SUBDIVISION REVIEW SHEET

CASE NO.: C8-2017-0154.01.2A

SUBDIVISION NAME: Interport Section 2C Final Plat

**CITY OF AUSTIN –DEVELOPMENT SERVICES DEPARTMENT
SUBDIVISION APPLICATION – MASTER COMMENT REPORT**

Exhibit B: Proposed plat

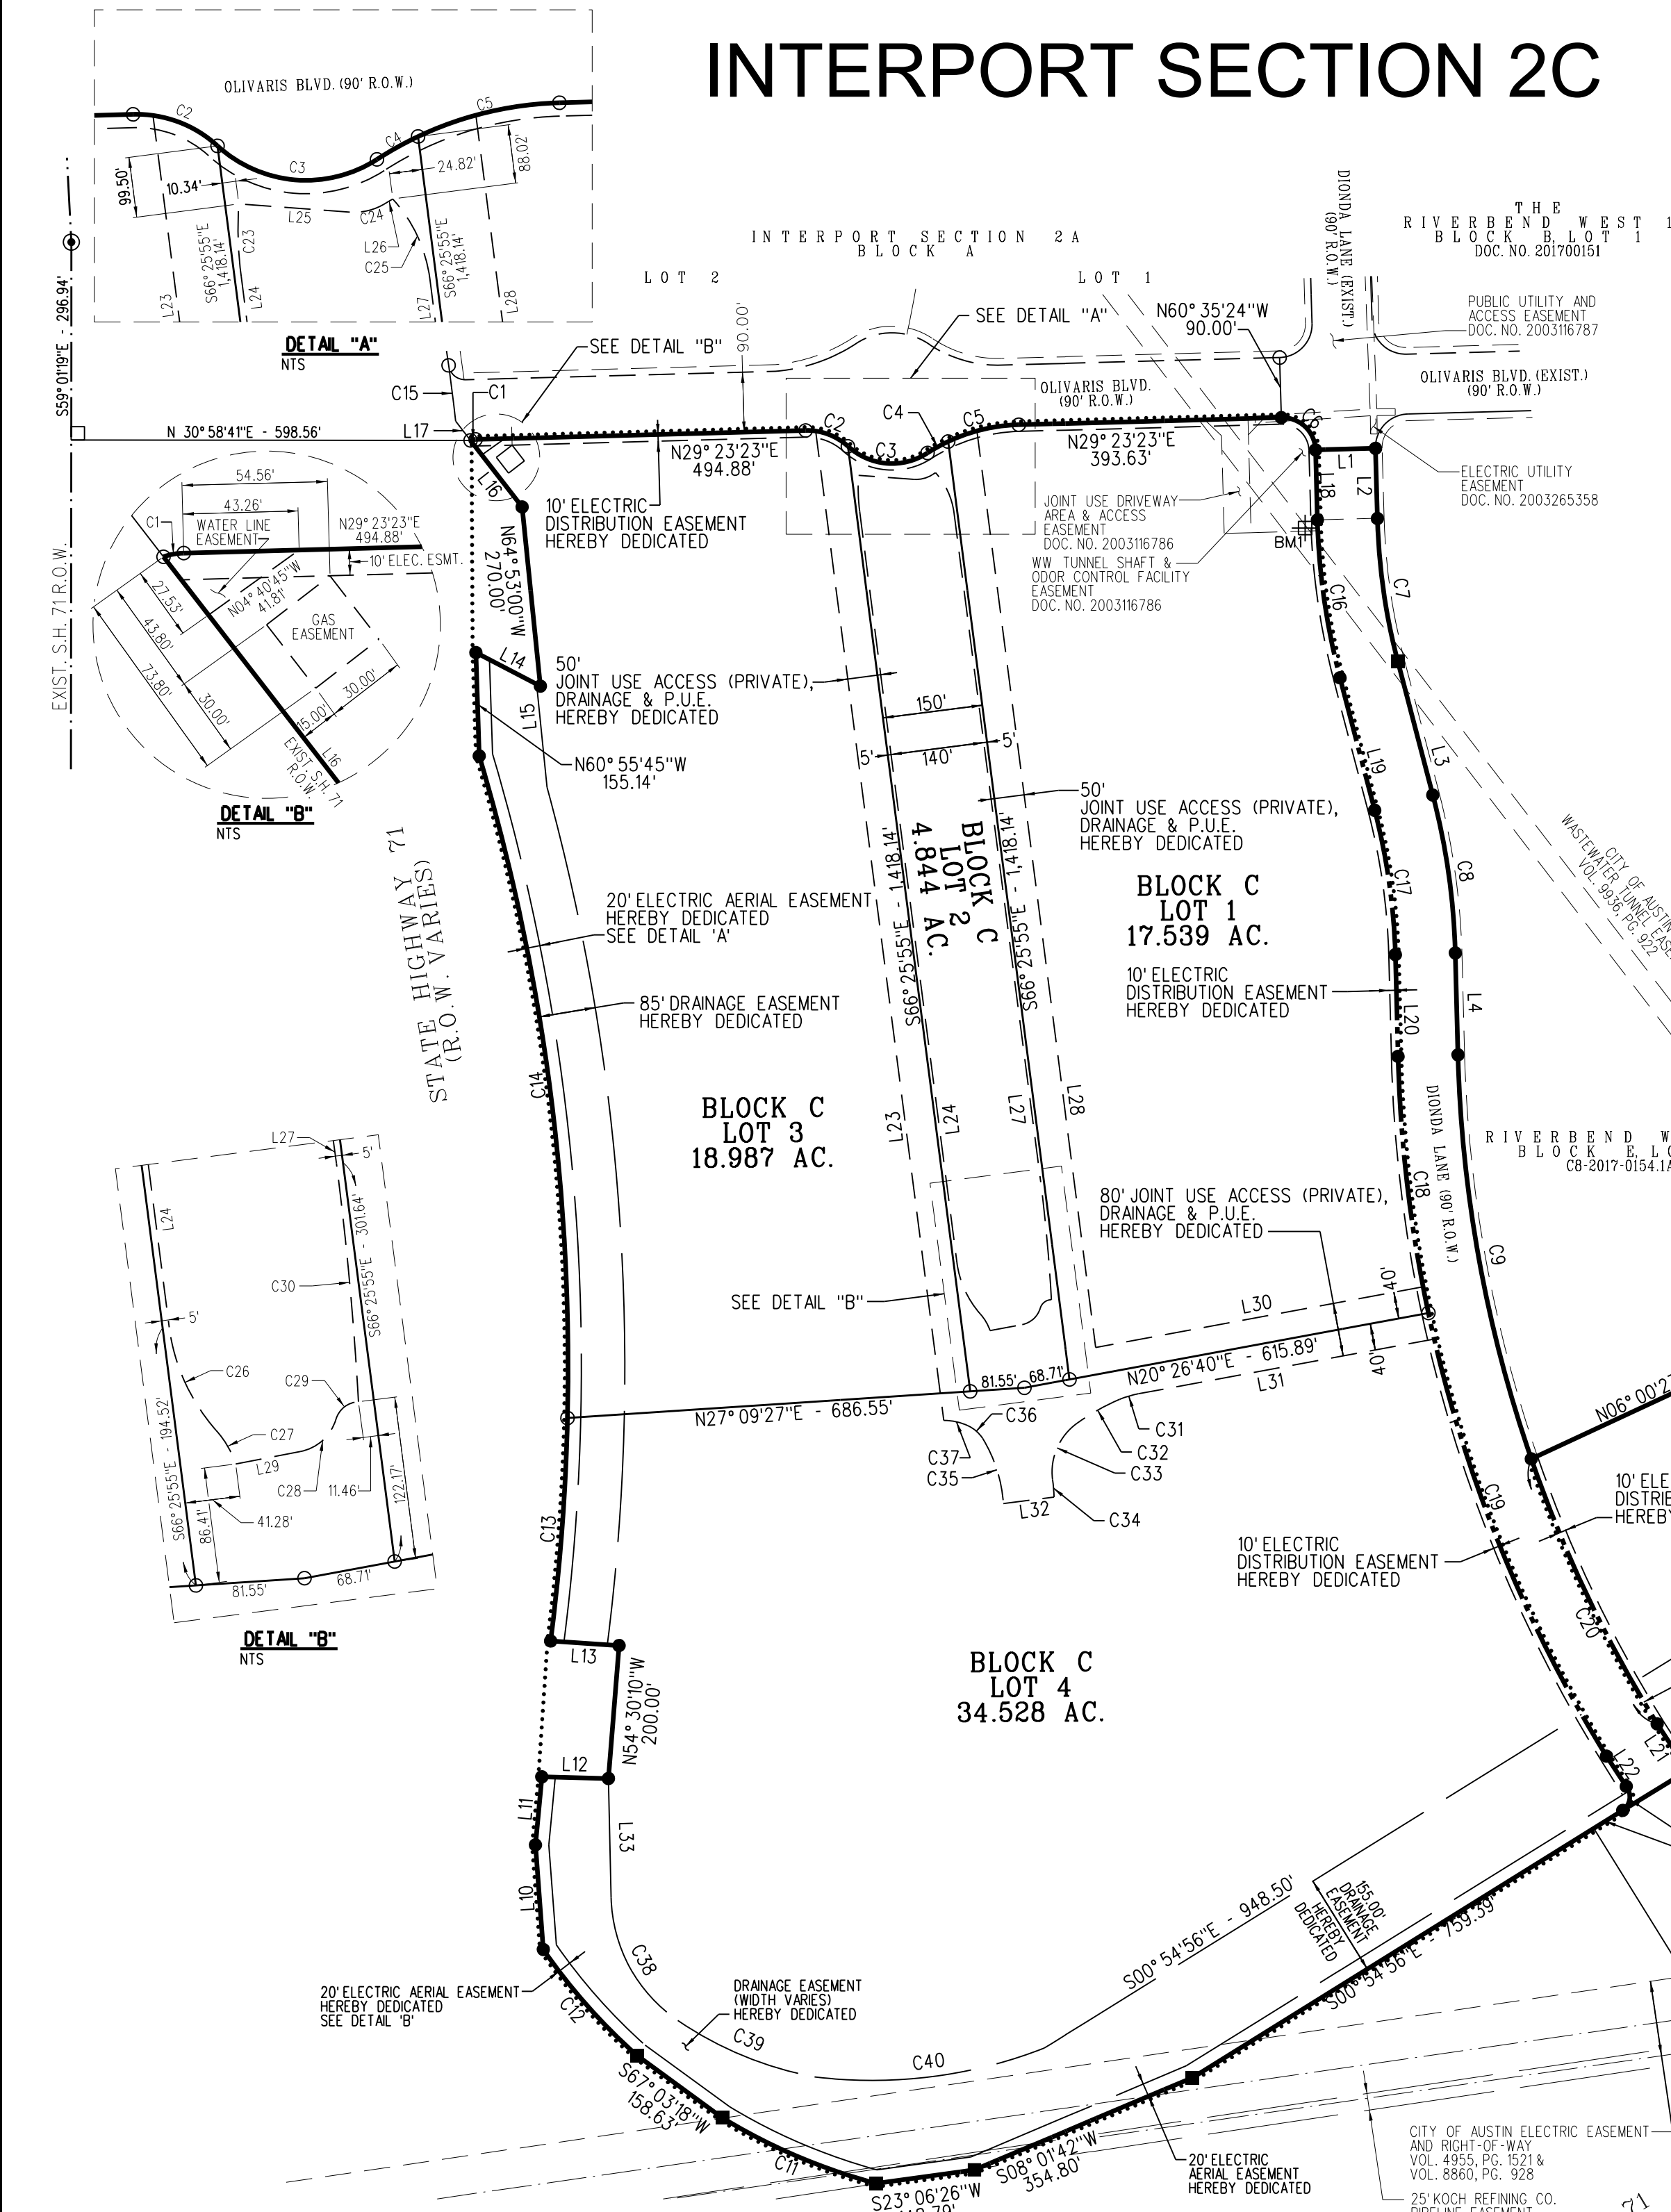
SR 10. The plat shows two Detail B blow ups as exhibits of an area. Label the blow up exhibits as B and C.

SR 11. In the Lot Summary Table on Sheet 2 remove the retail uses, the Park Dedication use should remain on the table. The lots will have uses allowed by approved zoning ordinance or as amended. 25-1-83, 30-1-113

Fifteen-foot electric distribution, electric telecommunications, and electric fiber easement is required adjacent to Olivaris Blvd. Show the easement(s) on the face of the plat.

WQ 6. Consider changing the names of the details. There are two Detail "B".

- PR3. Parkland dedication is required per Chapter 25-1, Article 14 (Parkland Dedication) of the City Code for this project. Show the property proposed to be dedicated parkland. Label Block C, Lot 2 as "Park." Contact the PARD reviewer for further discussion.
